**EPA Assessment of SSD8294 Environmental Impact Statement (EIS) – Mt Piper
Energy Recovery Project**

ATTACHMENT A: Mt Piper Energy Recovery Project EIS

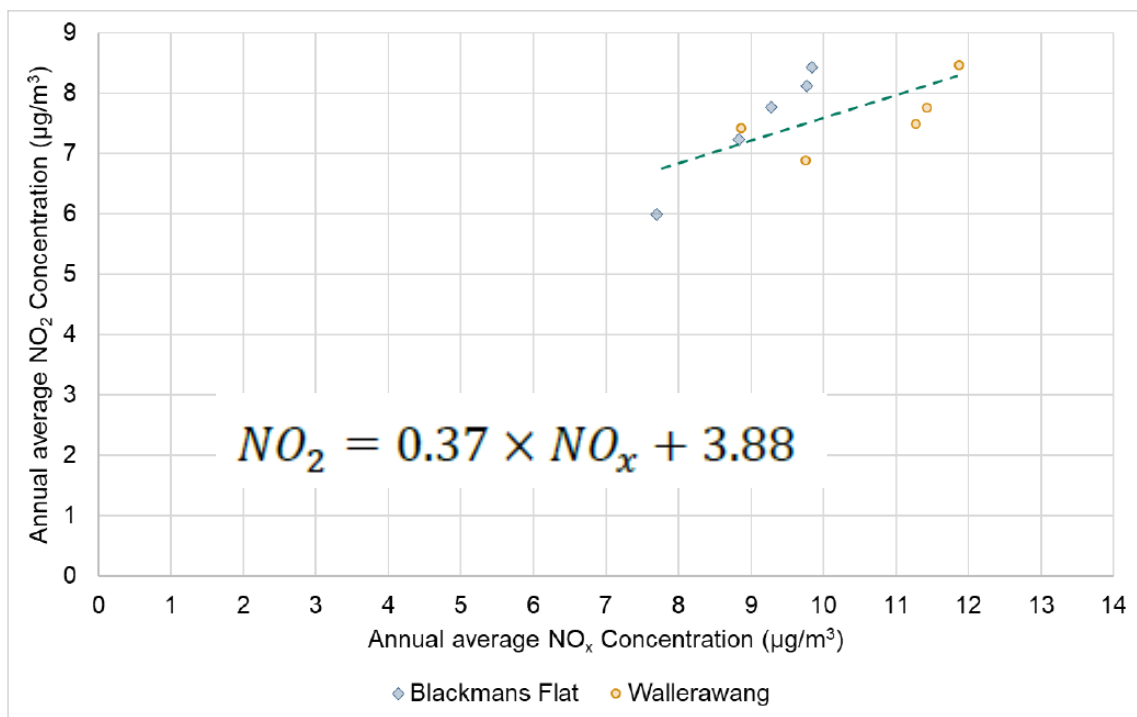
EPA advise the AQIA does not adequately justify the assumed metal distributions for the Regulatory Case. It is unclear if the source of the assumed metals compositions in the AQIA, “European Union compilations of in-stack metals distributions (Ramboll, 2016)”, is appropriate for the Mt Piper ERP proposal. Ramboll (2016) is a technical memo prepared to support the air quality impact assessment for the Genesis Energy from Waste Facility in Eastern Creek. The technical memo appears to refer to operational data from the reference facility for the Genesis proposal. A different reference facility is being used for the Mt Piper ERP. Further, reference is made to an outdated version (version 3) of the UK Environment Agency’s monitoring data from municipal waste incinerators. The assumed emission concentrations for arsenic and nickel are also significantly below the UK1 waste incinerator emissions data.

EPA also advise that calculation of emission concentrations using the normalised flow rate show the ERP would not be in compliance with the Group 6 POEO Clean Air Regulation emission limit for Type 1 and 2 substances (in aggregate) of 1 mg/m³ at 7 % O₂ (0.71 mg/Nm³ at 11 % O₂ used in the AQIA).

EPA advise that calculation of emission concentrations using both actual and normalised flows (Table 8.1) show the ERP would not be in compliance with the EU’s IED emission limit for aggregate metals (9 metals Table 8.2). It is also likely that the assumed metal emission concentrations for the ERP would not align with the SBE pollutant air emission guarantee.

- 12) the proponent provide further information justifying all assumed Regulatory Case metal emission concentrations and rates from the proposed ERP.
 - 13) the proponent must consider and present options for metal emissions that will achieve compliance the Group 6 POEO Clean Air Regulation emission limit and align with the SBE pollutant air emission guarantee.

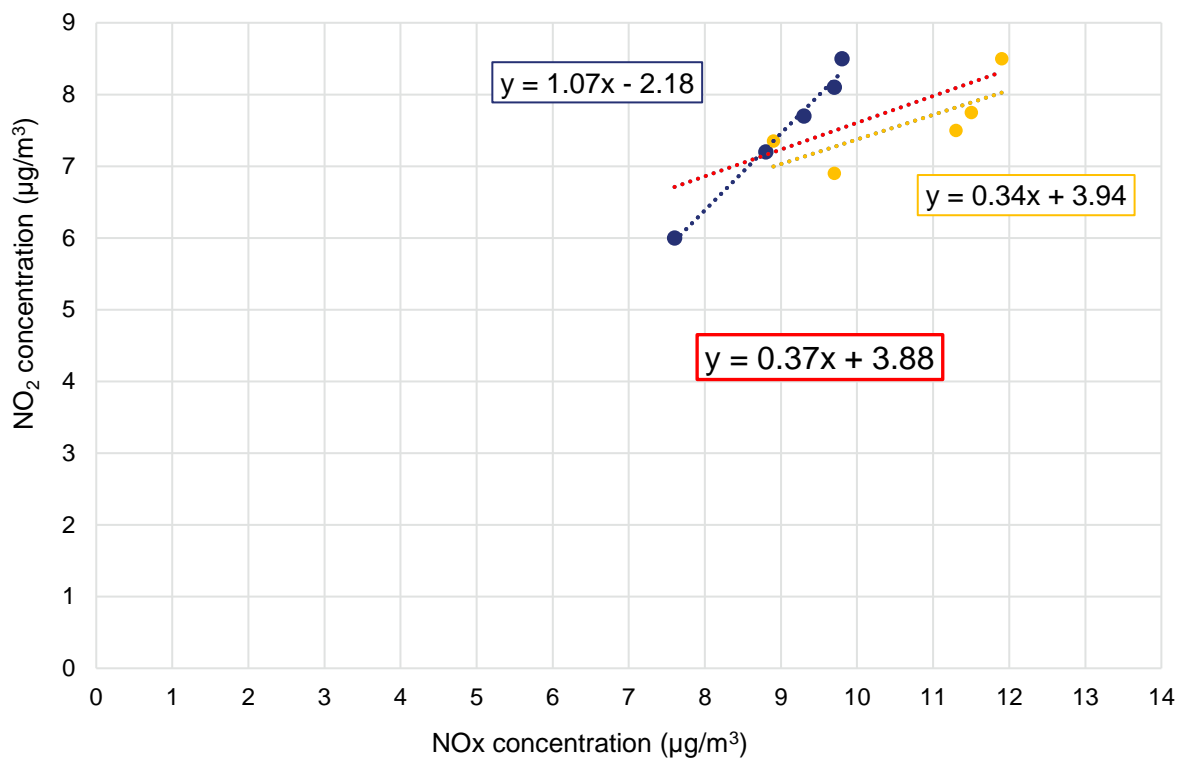
The AQIA assessed annual average NO_x to NO₂ conversion using a linear regression equation derived from data collected at Blackman's Flat and Wallerawang (Figure below from Appendix B of AQIA).

EPA advise that this method is not an EPA approved NO_x conversion method. The linear regression used is heavily influenced by the Wallerawang data (see Figure below). Considering Blackmans Flat is closer to the Mt Piper Power Station and has close to a 100 % NO_x conversion rate, it would be considered a more conservative and appropriate approach to assume 100% NO_x to NO₂ conversion, which is also in accordance with the NSW EPA's *Approved Methods for Modelling and Assessment of Air Pollutants in NSW*.

- 14) the proponent prepare a revised AQIA that assumes 100% NO_x to NO₂ conversion for annual average concentrations.
 - 15) the proponent investigate the accuracy of their NO_x conversion method.
